CITY OF ALBUQUERQUE

**RE: 1100 Ridgecrest Dr. SE
Grading and Drainage Plan
Engineer's Stamp Date: 07/02/21
Engineer's Certification Date: 06/25/22
Hydrology File: L17D027**

DAVID SOULE P.E. #14522	ENGINEER'S SEAL	LOT 1 BLOCK 40 PARKLAND HILLS 1100 RIDGECREST DRIVE GRADING AND DRAINAGE PLAN	DRAWN BY DEM
	DATE 6-30-21		LOT 1 BLOCK 40 PARKLAND HILLS DWG
 Rio Grande Engineering P.O. BOX 53924 ALBUQUERQUE, NM 87199 (505) 321-8099	7/2/21	SHEET # C1	JOB #

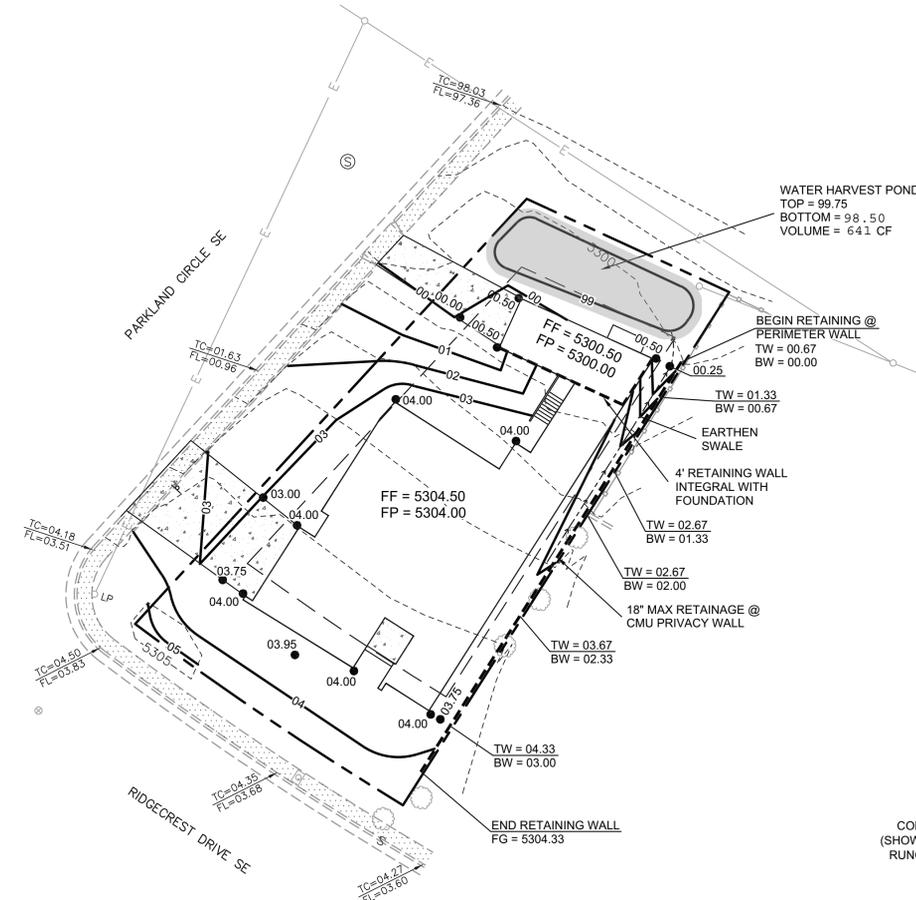
Based upon the information provided in your submittal received 07/14/2022, the Grading and Drainage Plan is approved for Building Permit and Building Pad Certification for 1100 Ridgecrest Dr. SE. Please attach a copy of this approved plan in the construction sets for Building Permit processing along with a copy of this letter.

1. Engineer's Certification, per the DPM Part 6-14 (G): Engineer's Certification Checklist for Subdivision and Part 6-14 (H): Required Certification Language is required.
